## **Exhibit R – USACE Comment Response Matrix**

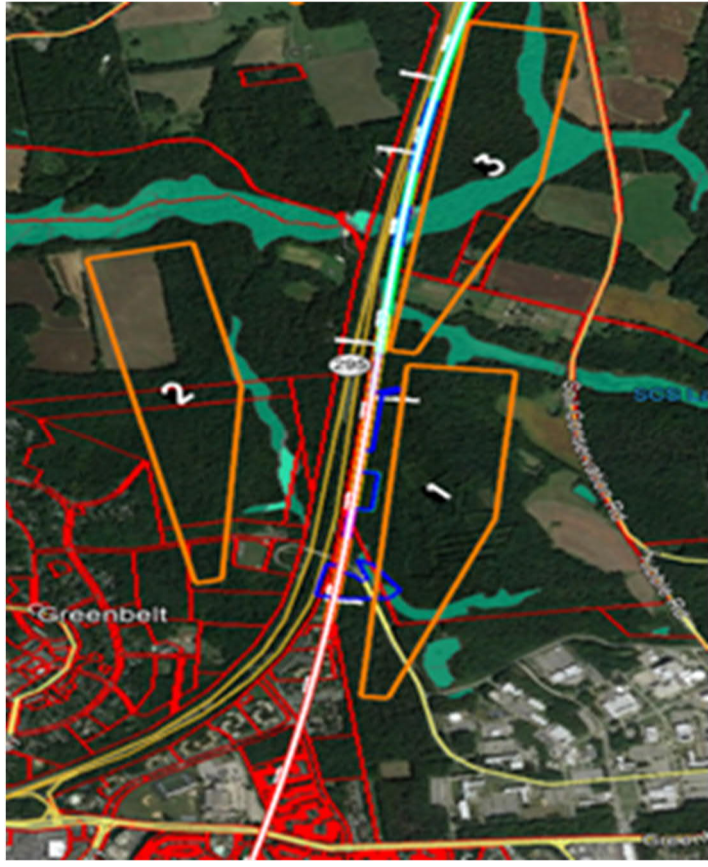
23	USACE-IP-7	<p>The headers on the Corps Waterway Impact Table appear to be out of order and are confusing. For example, the "Classification" column lists design impact type codes. It is unclear what is represented by the numbers in the "Tributary To" and "Design Impact Type" columns. Are these the permanent impacts associated with the listed waterway? Please update this table to clarify.</p>	<p>Headers have been updated correctly in the revised Exhibit A.</p>
